ADDENDUM TO: VISTA-128BPT, VISTA-250BPT Series

(Use with Issue 800-06903)

RE: Important information about features that are new or changed in the Vista Turbo Series and its peripherals

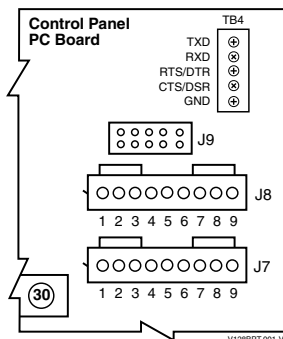
The J8 connector is no longer used for direct connect, serial printer or home automation applications. On all Vista Turbo Series panels, there are two methods of connecting to the serial (printer/automation) port:

NOTE: TB4 and J9 support WIN-PAK, however if you want to connect to a printer you must use TB4.

- 1) Using flying leads from terminal block TB4 to a 9- or 25-pin serial connector.
- 2) Plugging the VT-SERCBL cable into header J9. This connector terminates in a 9-pin serial connector. To connect this to a PC, you must use a standard straight through serial cable with a 9-pin connector on the panel end and the appropriate connector for your PC on the other end.

The TB4 method is intended for permanent wiring, e.g. when connecting to WIN-PAK or Pro-Watch. The J9 method is ideal for direct-connect programming, where the serial connection being made is only temporary.
